World Forum for Harmonization of Vehicle Regulations

Working Party on Lighting and Light-Signalling

Proposal for [01] series of amendments to Regulation 23 (Reversing lamps)

Submitted by the Chair of the task force on courtesy lamp of the Working Party on Lighting and Light-Signalling *

Figure
Marking for single lamps

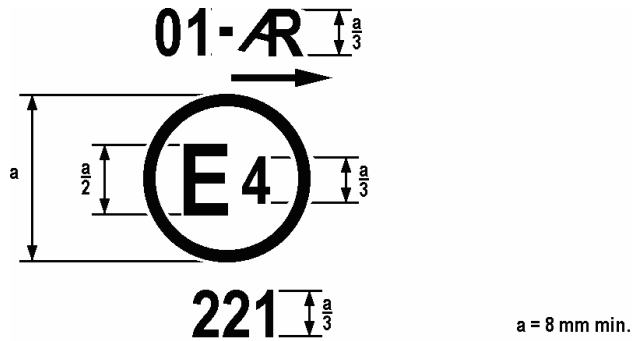
The device bearing the approval mark shown above is a reversing lamp approved in the Netherlands (E4) pursuant to Regulation No. 23 under approval number 221. The approval number indicates that the approval was granted in accordance with the requirements of Regulation No. 23 ~~in its original form or as amended by Supplements 1 and/or 2, as the case may be~~ by the [01] series of amendments. The arrow indicates the side on which the required photometric specifications are met up to an angle of 45° H.

Model E

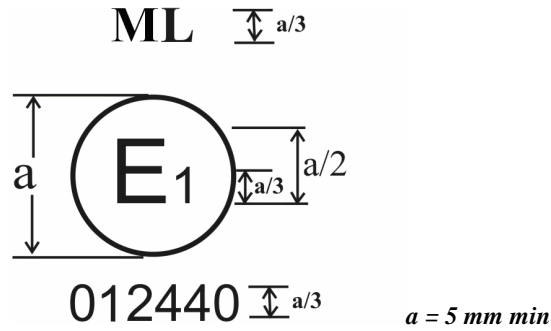
The above example corresponds to the marking of a lens intended to be used in different types of lamps. The approval marks indicate that the device was approved in Spain (E9) under approval number 1432 and comprises:
